City of Chipley

Development Order Application
The property is located at 1621 Main Street, Chipley, Florida and is in the Commercial zoning district. The purpose of the review is to identify whether the proposed development is consistent with Part II of the City of Chipley Code of Ordinances. Deficiencies of the applications are indicated in red throughout this memo based on the application materials provided. The applicant has sufficiently addressed all comments. There are some additional permits and documentation that will be required to be submitted once received as noted throughout in **orange**.

SITE PLAN FOR PICKUP EXPANSION

Sheet No.
V1.1

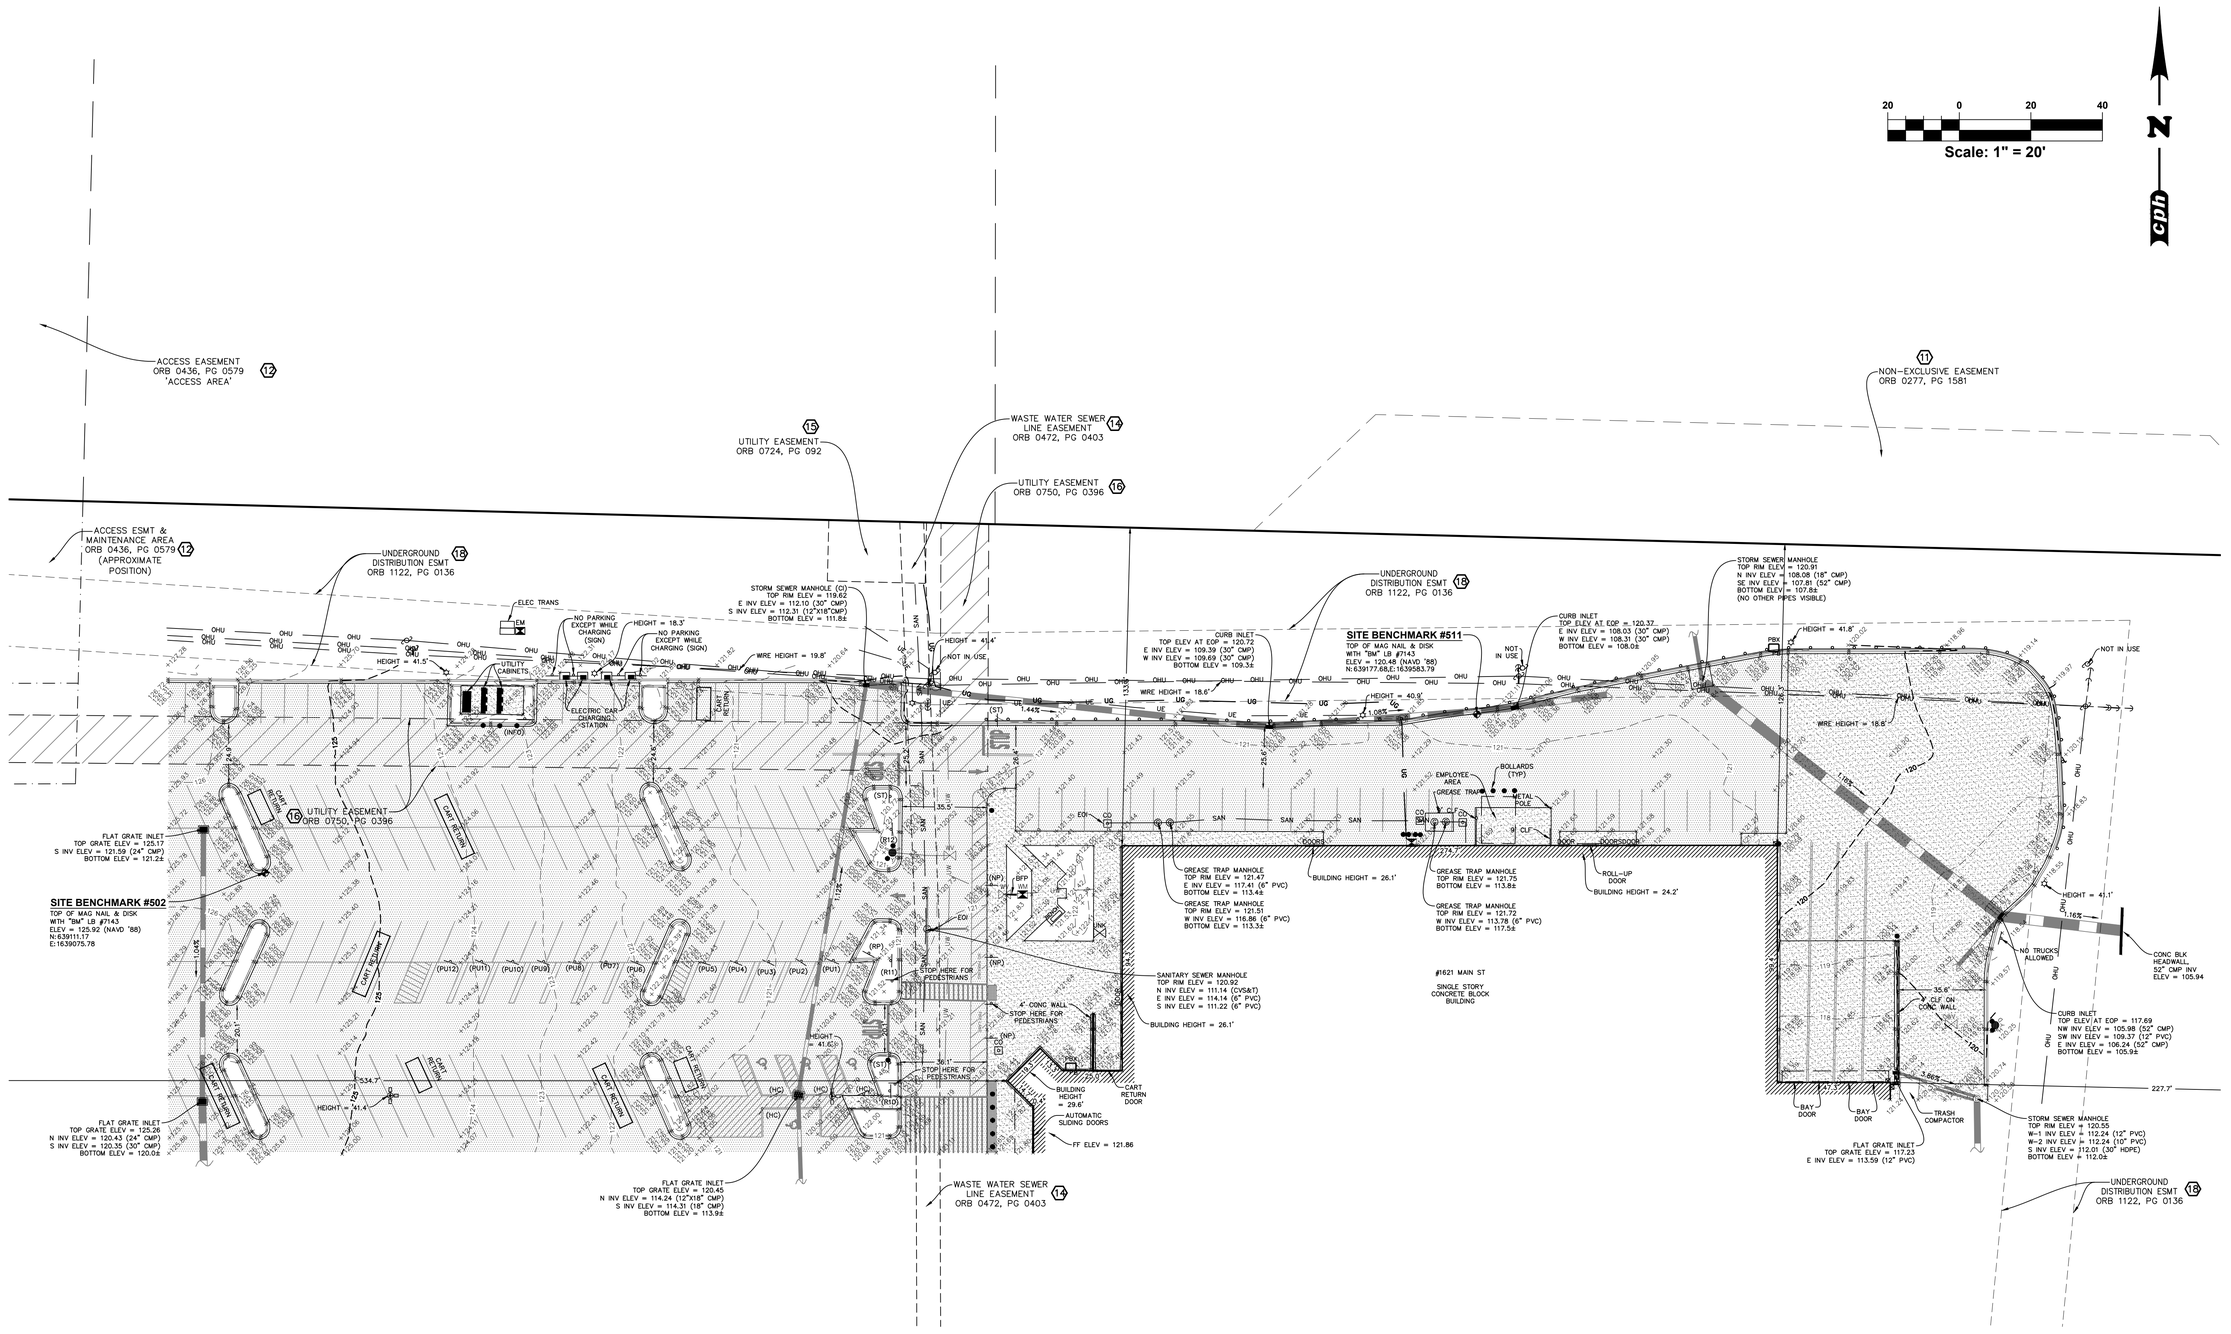
Sufficient: Provided in Plan Set: Sheet V1.1.

Sufficient: Provided in Plan Set: Sheets V1.1 & V1.2

Sheet No.
V1.2

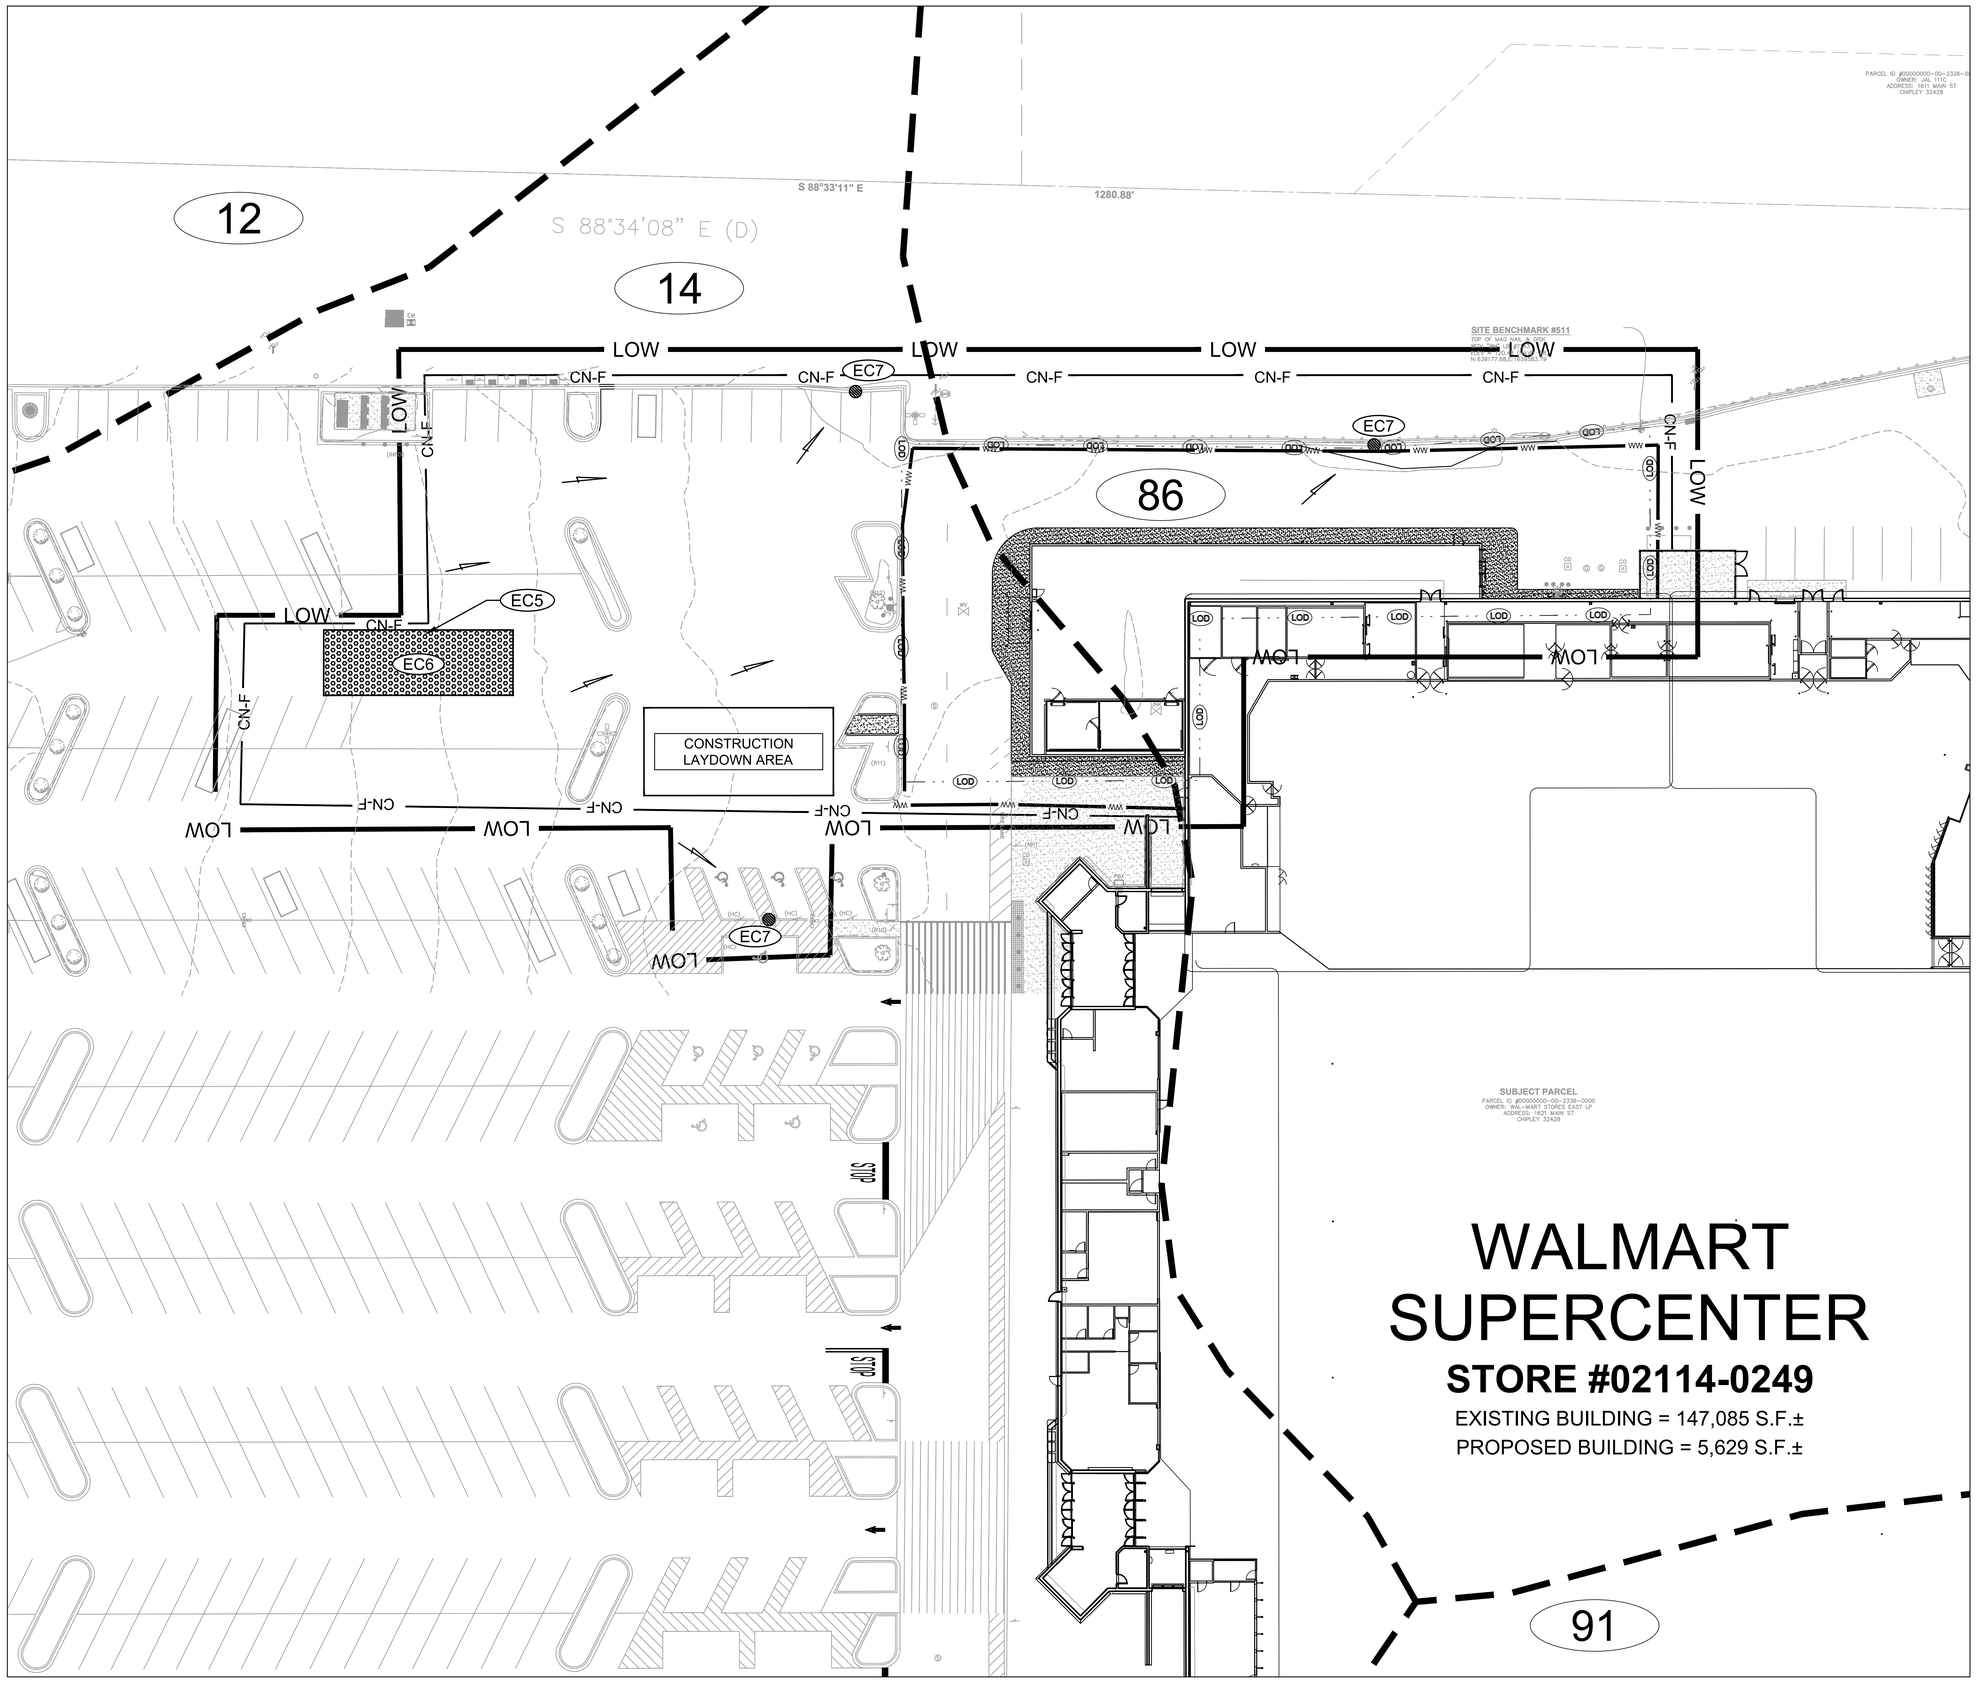
Sufficient: Provided in Plan Set: Sheets V1.2 & C1.4

SHEET: C1.0

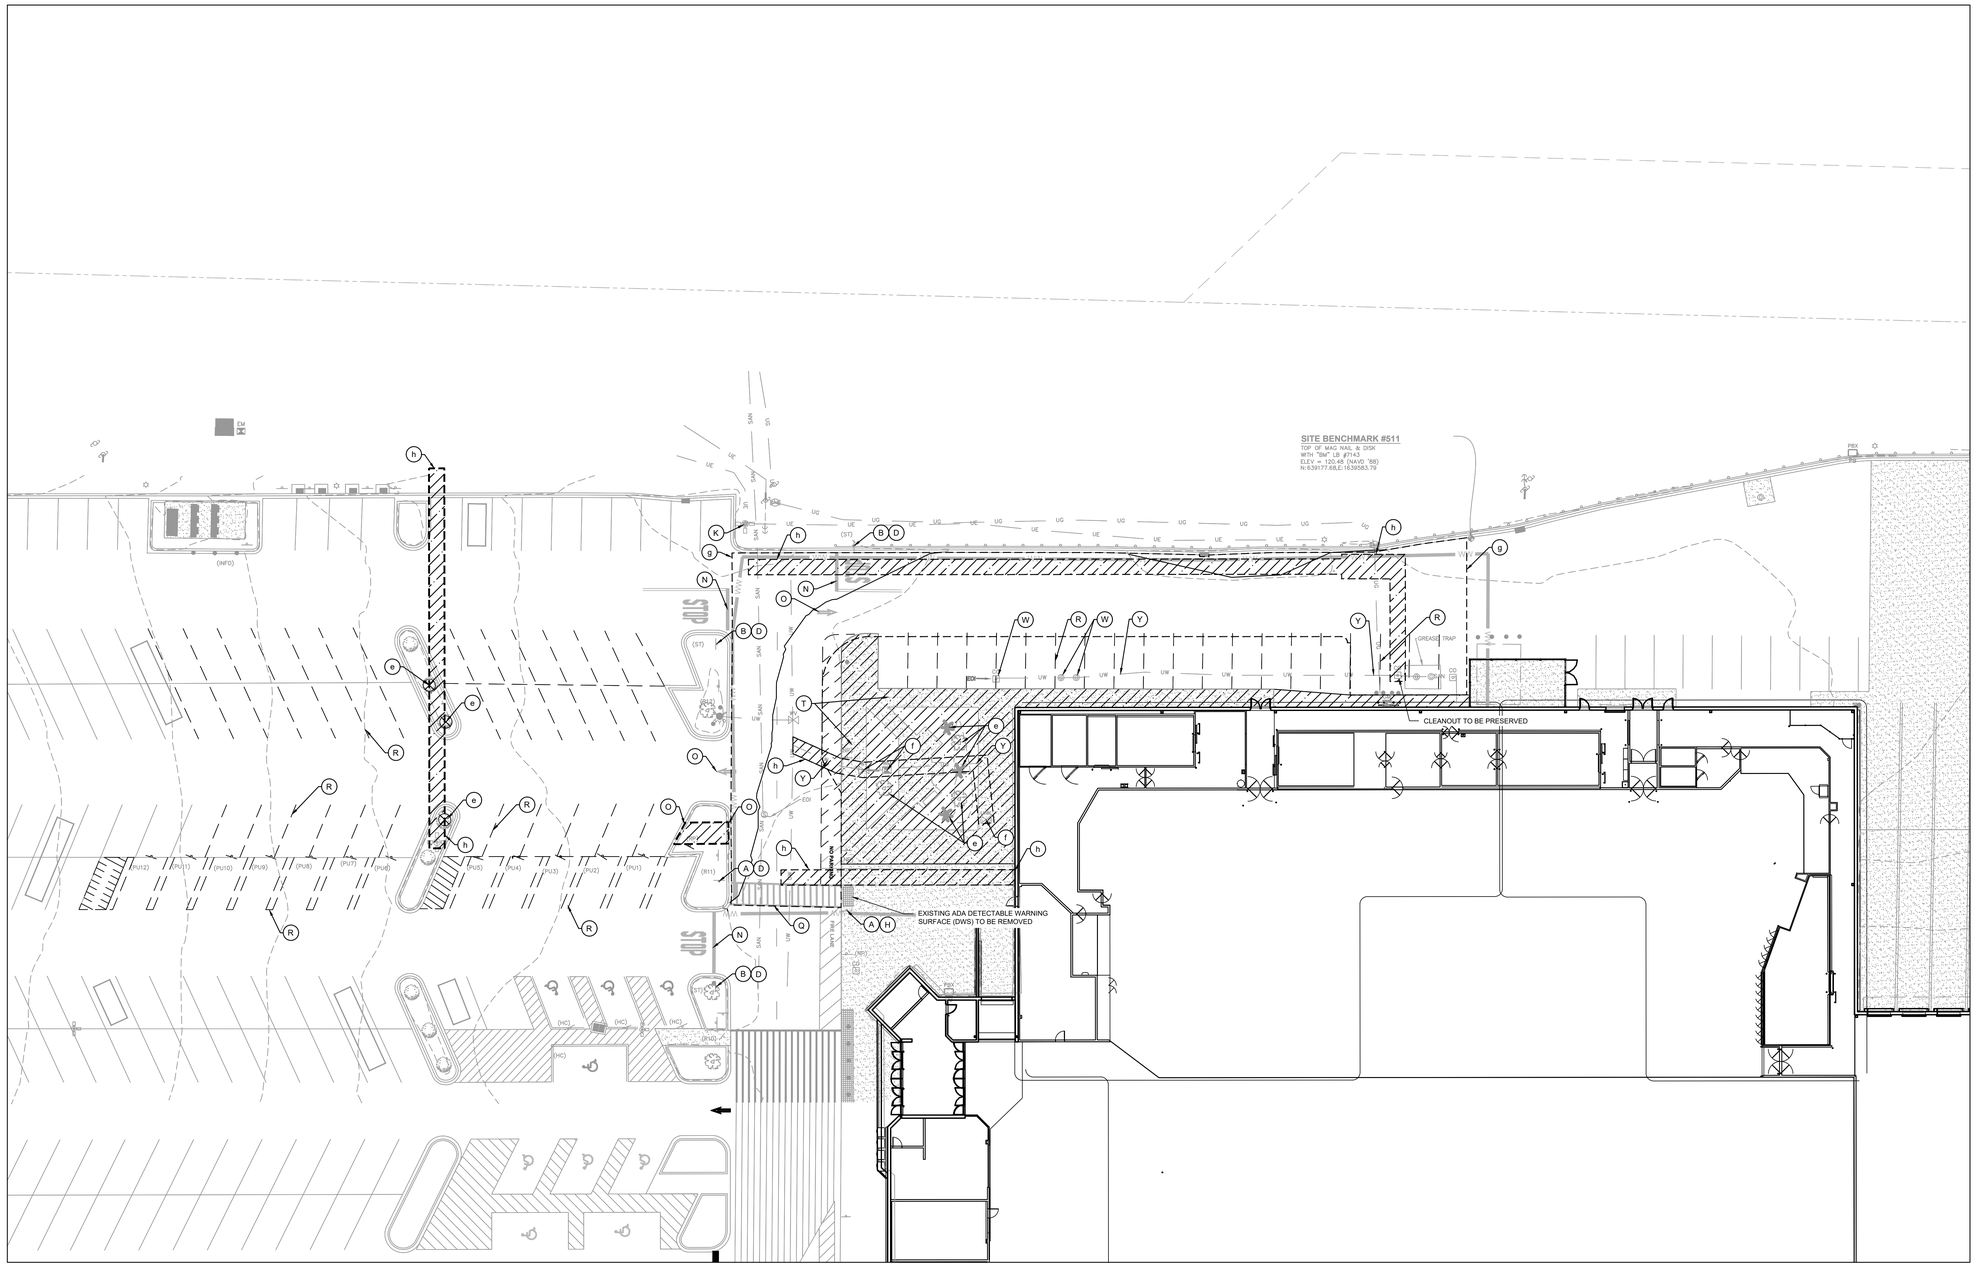
Sufficient: This subsection may be required by zoning commission but a Stormwater Management Plan is provided C1.0 & C5.4.
